INLAND FISHERIES AND WILDLIFE NATURE PARK - ADDENDUM #1

date: May 13, 2024
project: Inland Fisheries and Wildlife Store and Admin Office Project # 3096
prepared by: Ryan Kanteres Simons Architects
Adam Wiles-Rosell Simons Architects
Mikayla Molta Simons Architects

Subject: **Addendum #1** to Bid Documents of April 23, 2024

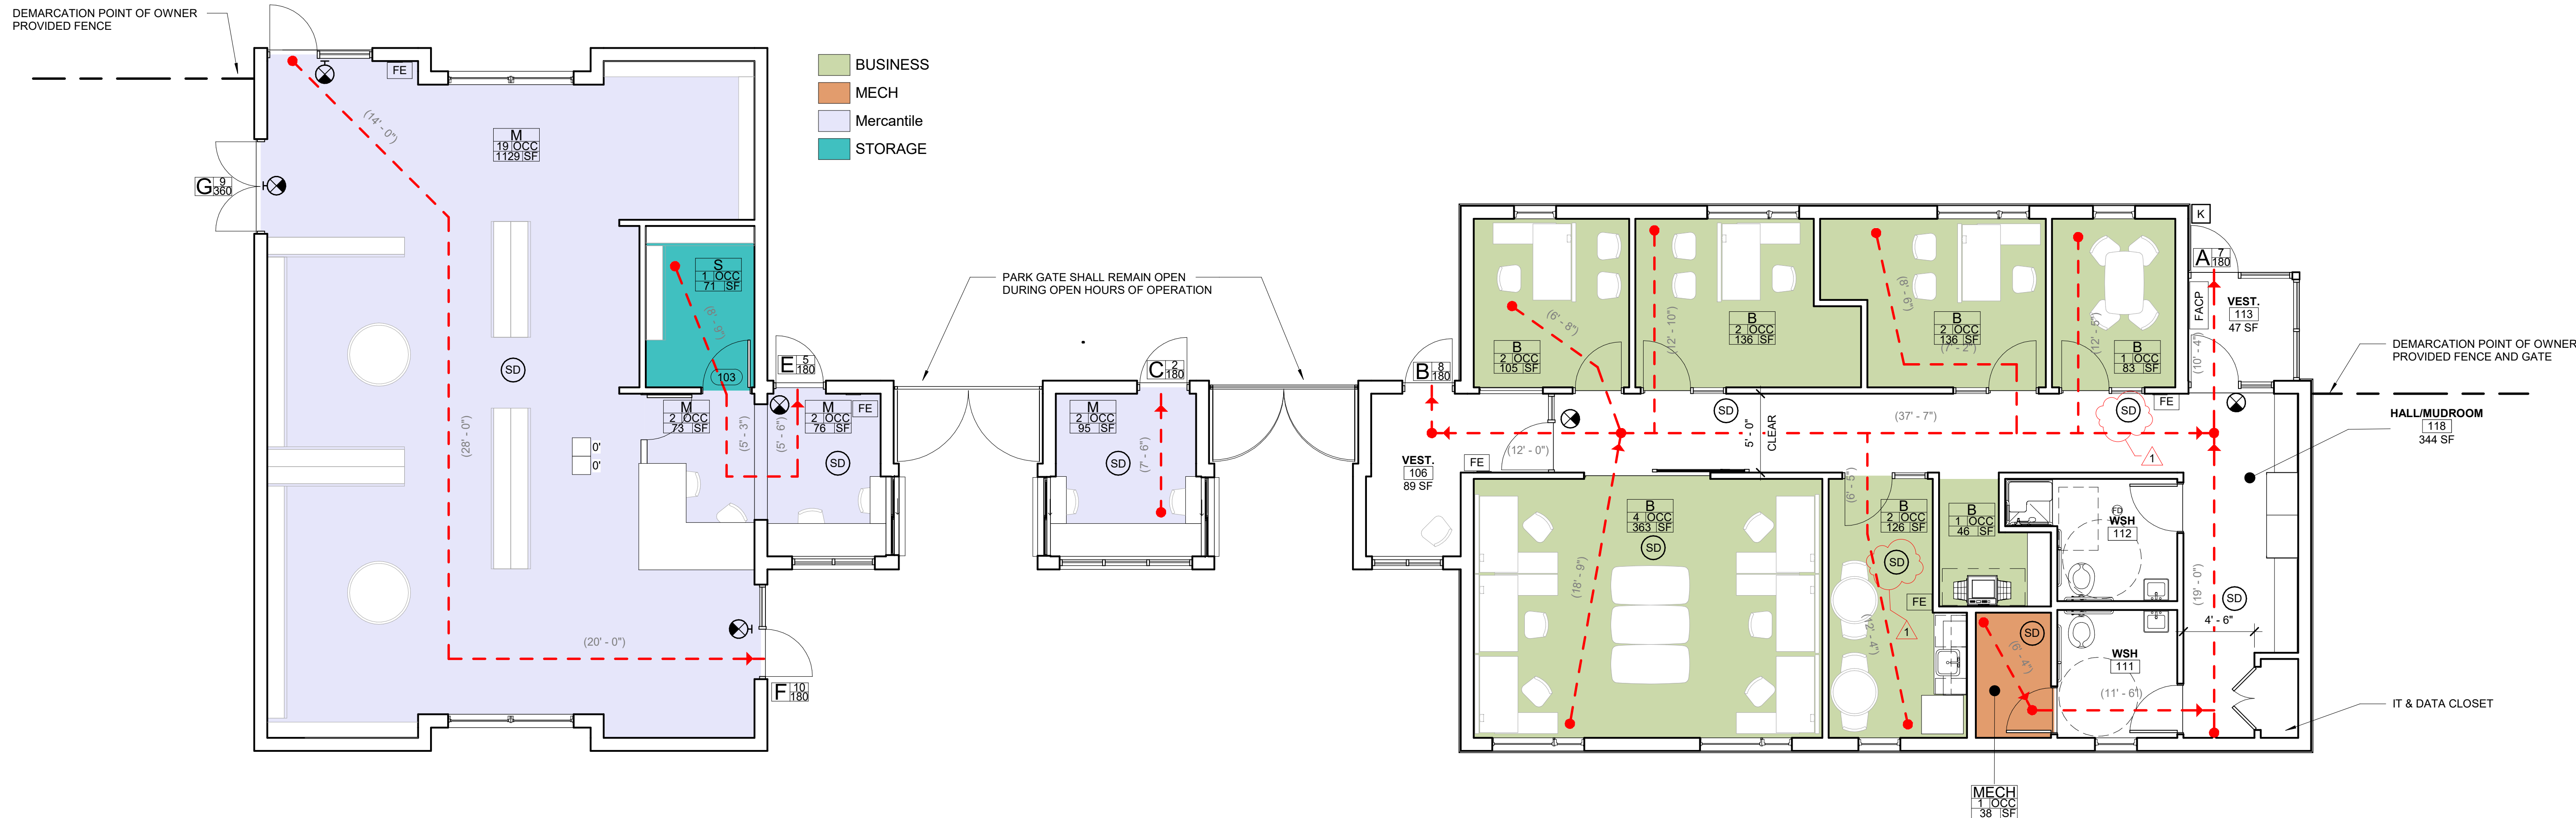
1-D3 Sheet G101 Coordinated smoke detector locations with MEP drawings.

C-101

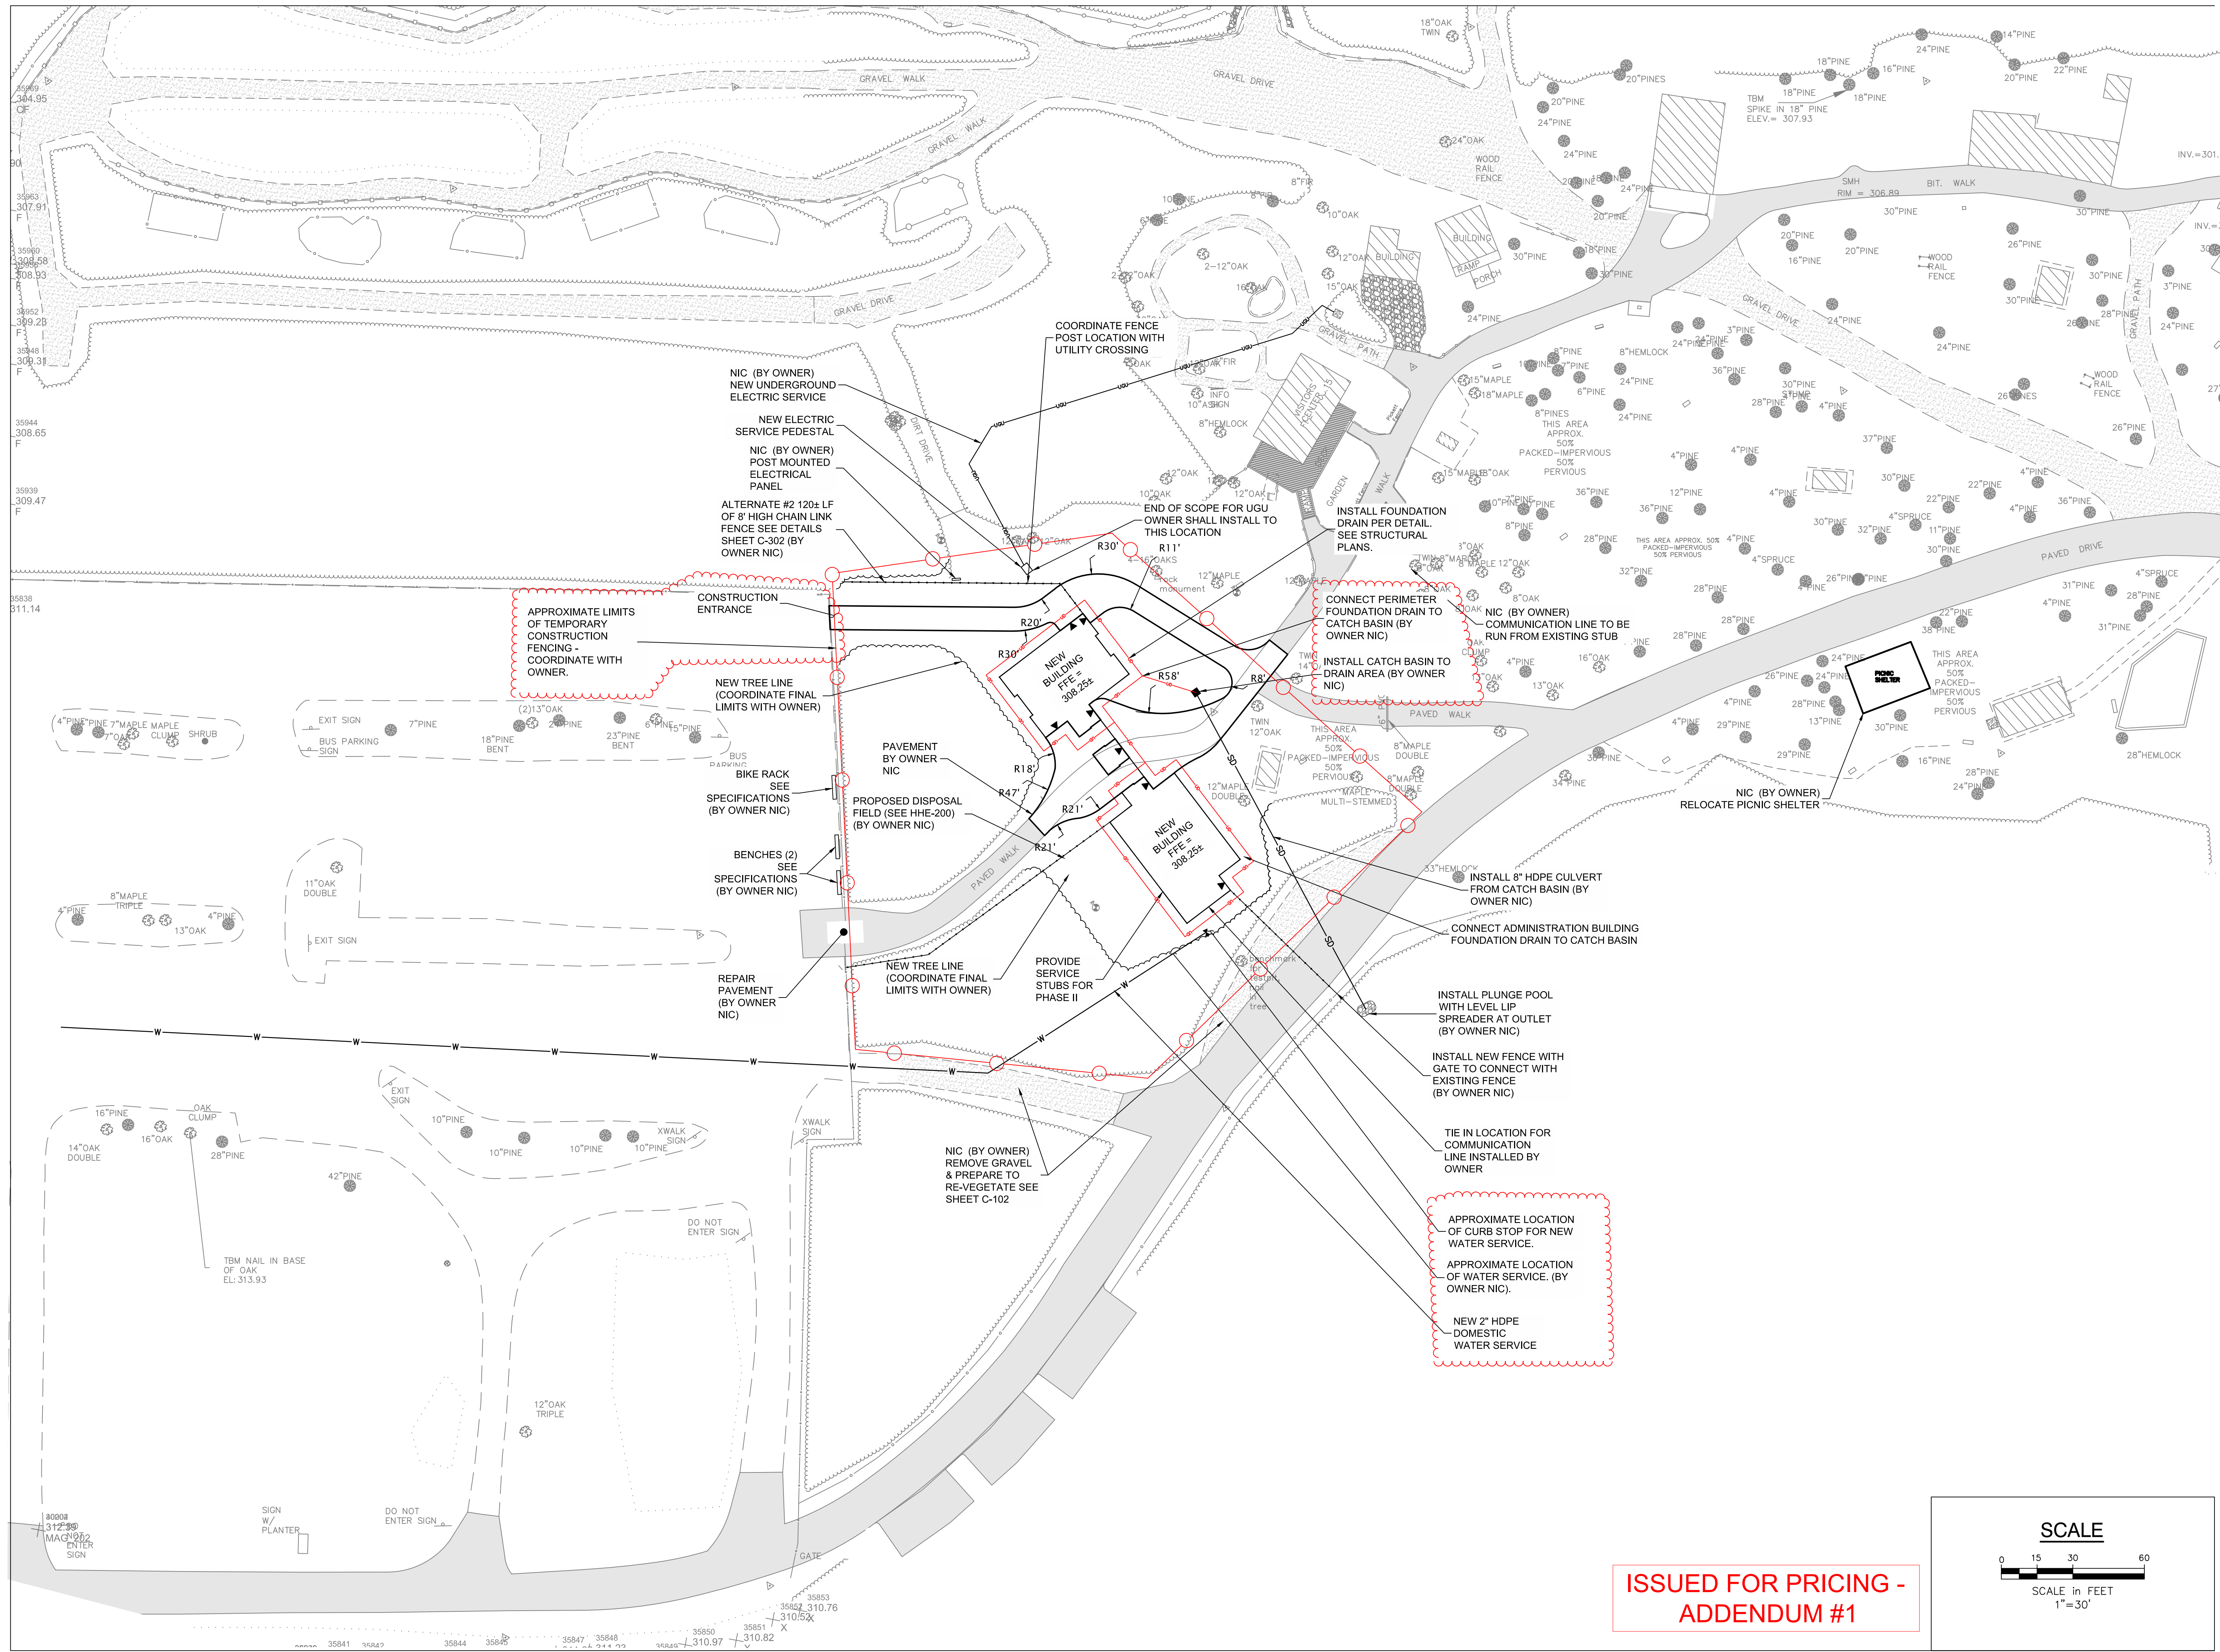
1-D4 Sheet C101 Rain chain connection to stormwater management coordinated. Drip strip (NIC) coordinated with structural details.

A000

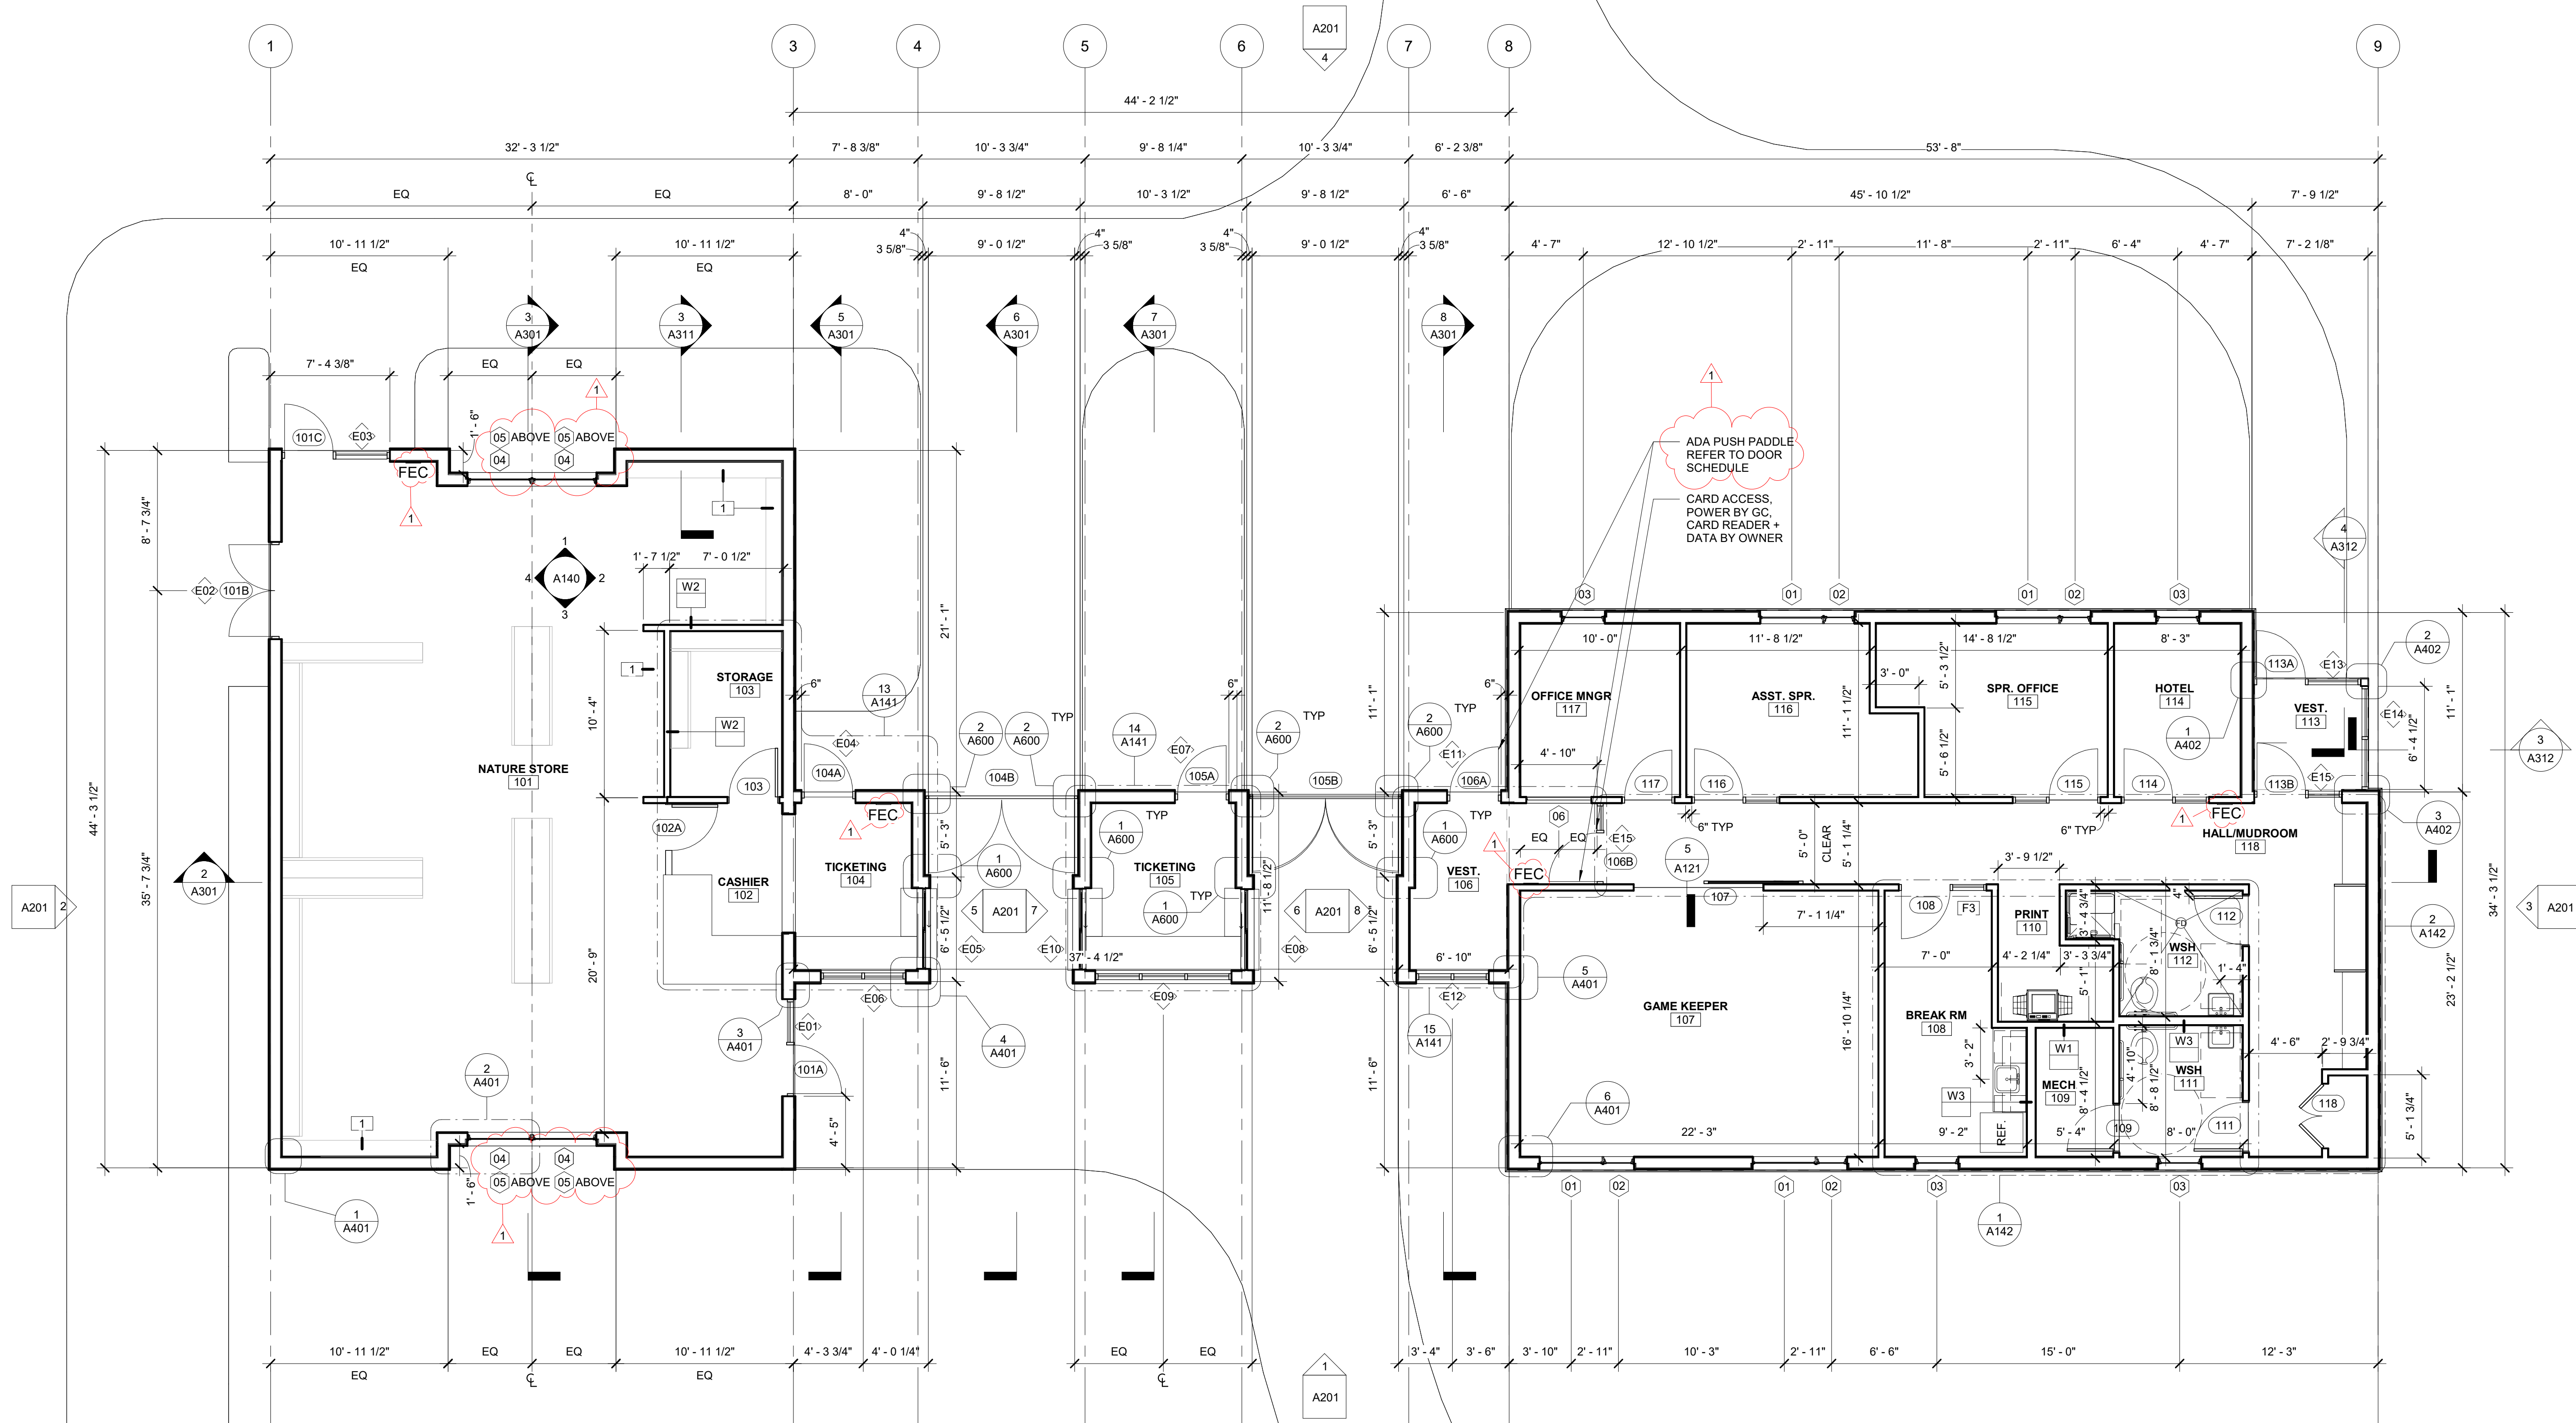
1-D5 Sheet A000 Adjusted sheathing size for wall assembly + roof types. Dimension clarification for sheathing and cedar breather. R4 2x8 rafters ILO 2x12 notched rafters. 2x6 insulation cavity provided. R3 to provide a furring layer.
